FINAL
MONITORING REPORT (MY2)

WARREN WILSON COLLEGE STREAM MITIGATION SITE

Response to Monitoring Year 2 (2021) DMS Comments

Warren Wilson College Stream Restoration Site
French Broad River Basin – CU# 06010105– Buncombe County
DMS Project ID No. 100019
Contract # 7188

Site	Warren Wilson
Watershed:	French Broad, 06010105
XS ID	UT 3, XS - 8, Pool
Feature	Pool
Date:	4/6/2021
Field Crew:	Perkinson

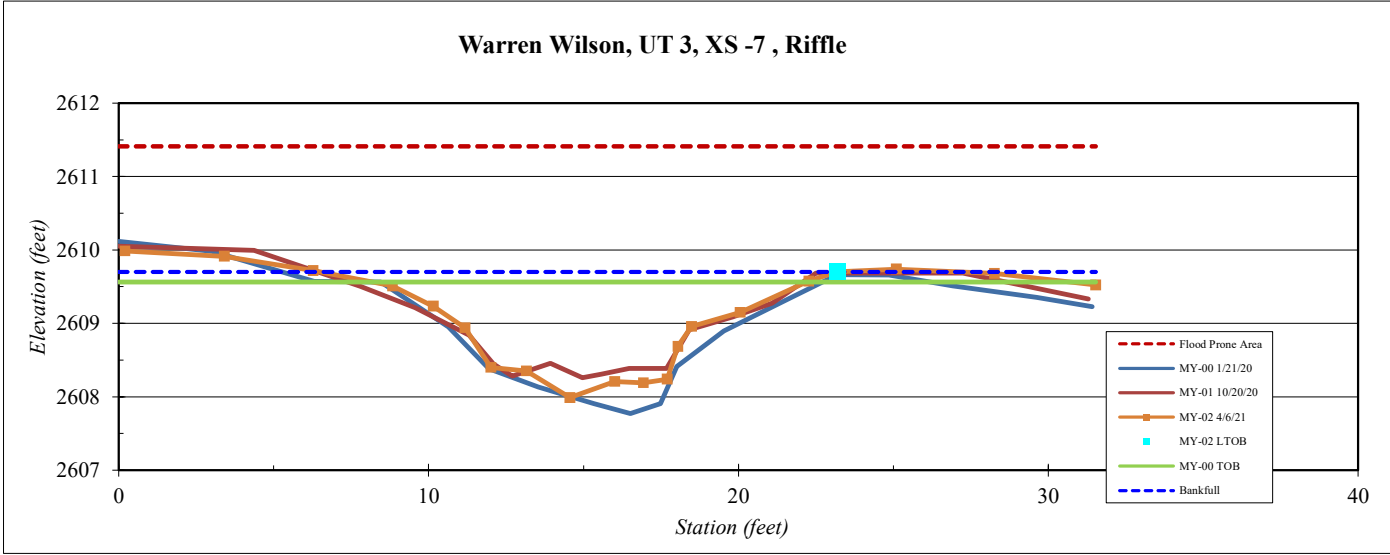
4. Cross Section (Warren Wilson, UT 3, XS - 8, Pool): This cross section highlights survey points from MY1 (2020). Please update the highlighted survey points to MY2 (2021).

Response: The highlighted survey points have been switched to MY2 (2021).
5. Appendix F - Preconstruction Wetland Hydrology Data: Figure 3 was corrupted in the draft .pdf report received. Please review and confirm there are no issues with the figure or final .pdf report. Please also optimize/ reduce the final report .pdf file size (if possible).
